City of Coral Gables Planning and Zoning Staff Recommendation

Applicant:	4225 Properties, LLC and 4311 Ponce de Leon, LLC
Applications:	Mixed Use Site Plan Review (continued from October 8, 2014 Board meeting)
Property:	4225 and 4311 Ponce de Leon Boulevard (4311 Ponce)
Public Hearing - Dates/Times/ Location:	Planning and Zoning Board, November 12, 2014, 6:00 – 9:00 p.m., City Commission Chambers, City Hall, 405 Biltmore Way, Coral Gables, Florida, 33134

Mixed use site plan review for the mixed use project referred to as “4311 Ponce”, as follows:

PONCE DE LEON BLVD.
SITE LANDSCAPE PLAN
 SCALE: 3/32" = 1'-0"

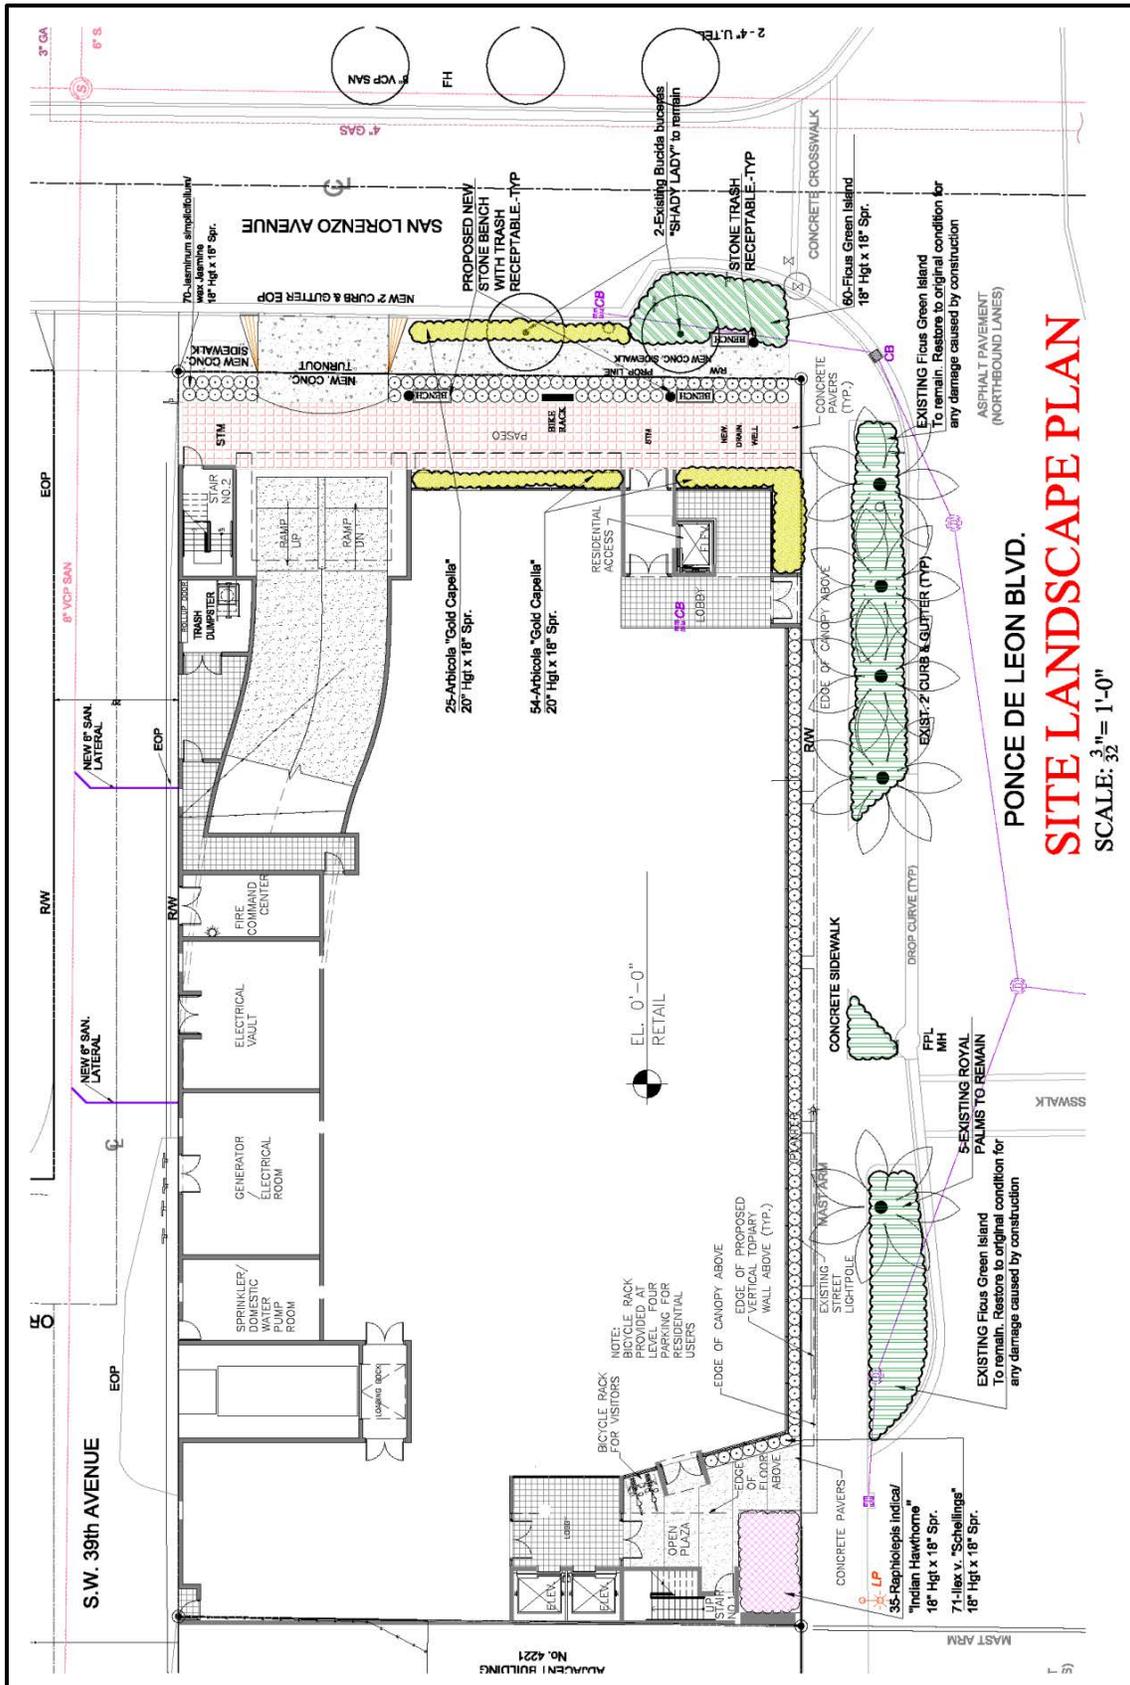
2. Planting bulb outs may be required at the alleyway and parking garage entrance on San Lorenzo Ave.
3. Some form of landscape needs to be incorporated on the street level in the alleyway. i.e. Creeping Fig growing on the walls, trellis structures with vines, etc.
4. Are the overhead wires in the alley way being relocated underground?
5. The balconies on levels five and six, particularly the east facing ones, need to have planters and irrigation incorporated into them since they face the blank wall of the adjacent building.
6. Consider screening the exposed parking on level four from the view of level five above.
7. The Residential Outdoor Plaza on level seven is confusing as to its purpose and functionality. What is the intended program/use for this vast covered area? More landscape should be considered to help define the space and enhance the functionality for the residents.

6. Since there is no tree canopy proposed within the property at the ground level, prior to the issuance of a building permit, a plan for small trees and/or palms on balconies, rooftops, and/or amenity decks need to be provided.

3. Subject to City approval of the right-of-way encroachment and Public Service and Public Works review, an 8"-12" planting area with irrigation along the base of the building fronting the ally shall be provided.

South (San Lorenzo Avenue) Building Elevation

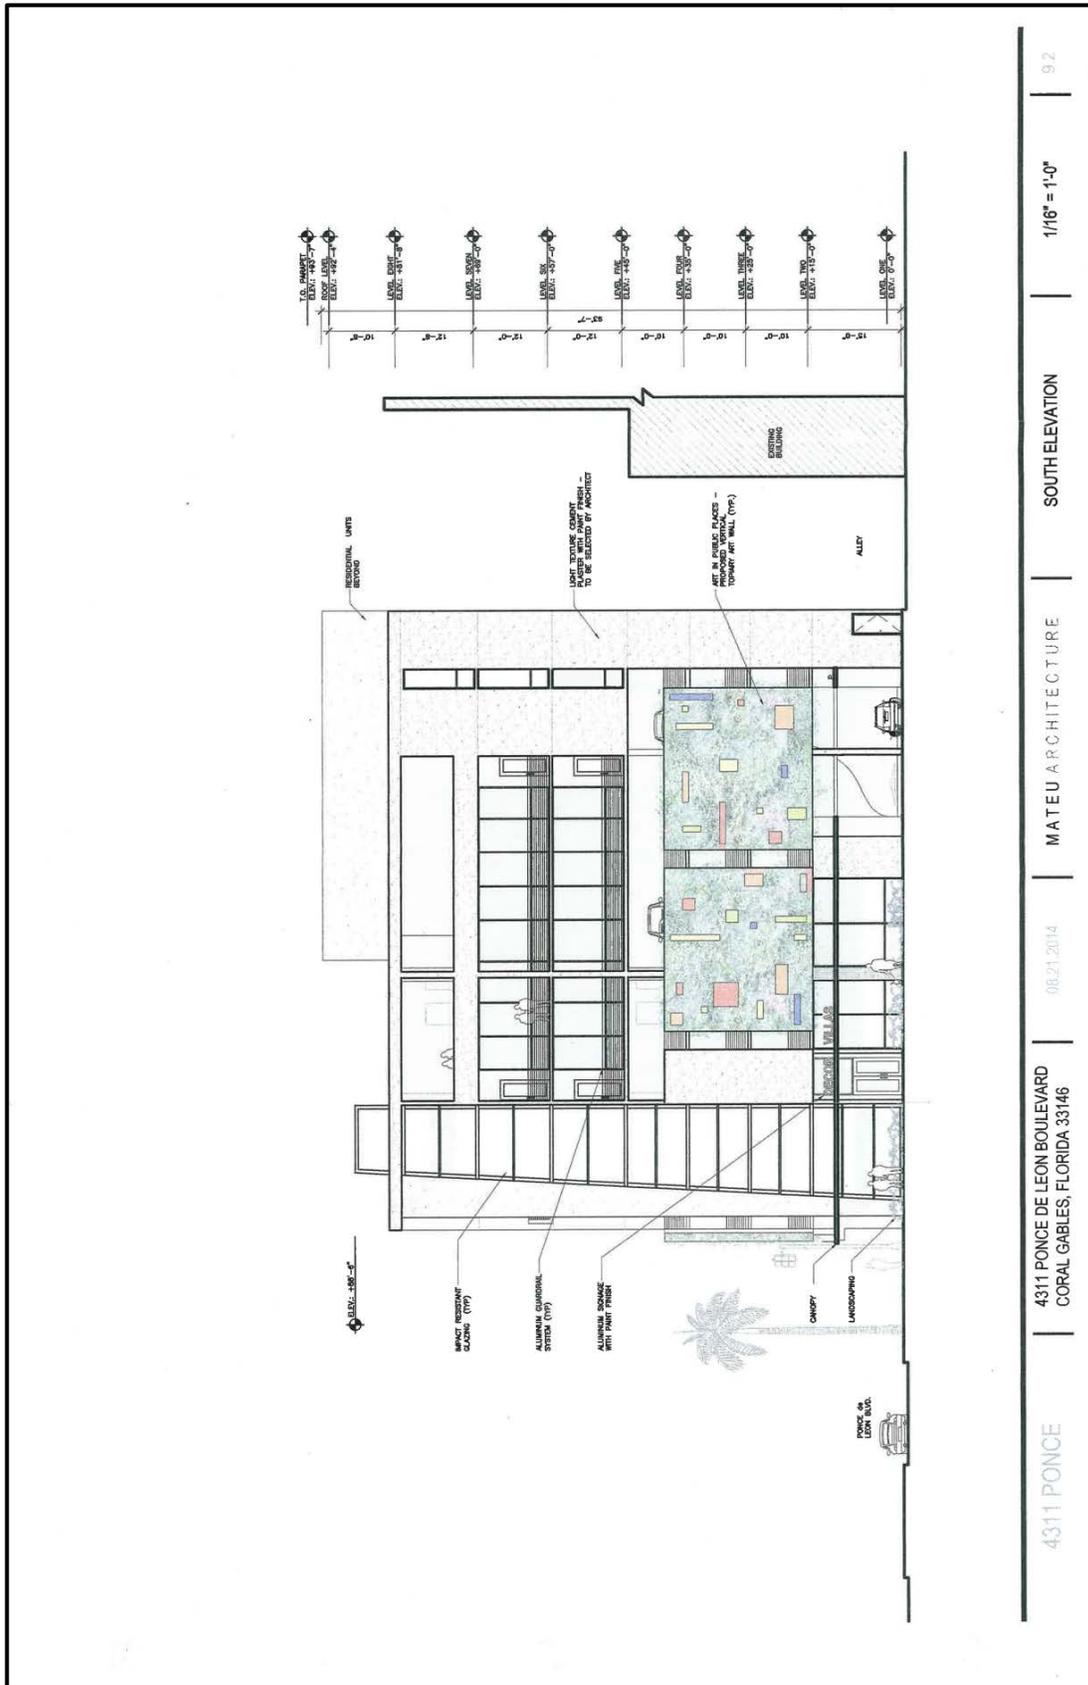
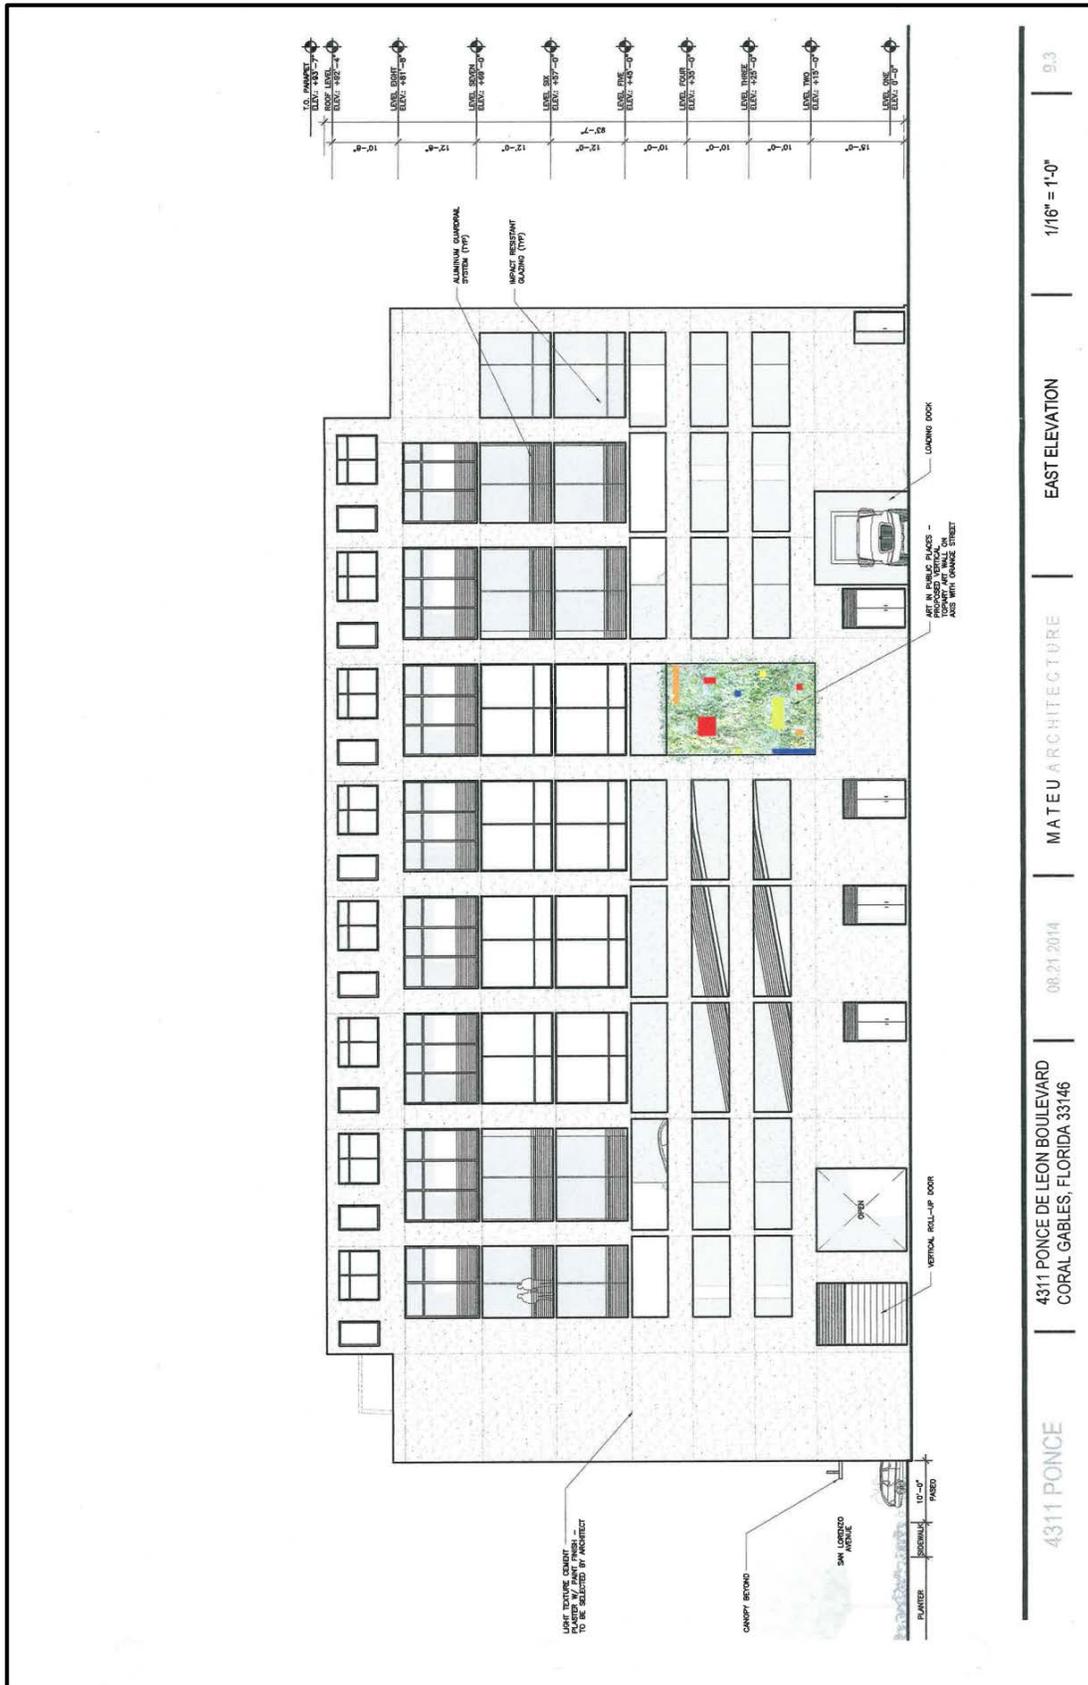
Currently, the project proposes a zero (0) foot front setback and 93'-7" building height, and does not provide a stepback on all building facades.

Staff comments: Since the proposed plans for the project were not revised, the project still does not comply with the requirements of the Zoning Code as identified in Item No. 1. Items No. 2 and No. 4 have been resolved. The comments provided by the Public Works Department regarding the Traffic Study have been satisfactorily addressed, and the Applicant held the required residents' meeting on 10.29.14. The Applicant provided responses to the comments concerning the landscaping identified in Item No. 3, and has proffered conditions that are acceptable to the Public Service Director. Those conditions are itemized in this Staff report, and would only be necessary if the Board recommends in favor of the Application.

- a. Provide the minimum ten (10) foot front setback for the entire building along the front property line (Ponce de Leon Blvd). A minimum front setback of ten (10) feet is required for buildings over forty-five (45) feet in height; or
- b. Comply with Zoning Code Section 4-201.E.15 for setback reductions. Applicant may provide zero (0) foot setbacks on all sides if vertical building stepbacks of a minimum of ten (10) feet are provided at a maximum height of forty-five (45) feet on all building facades.
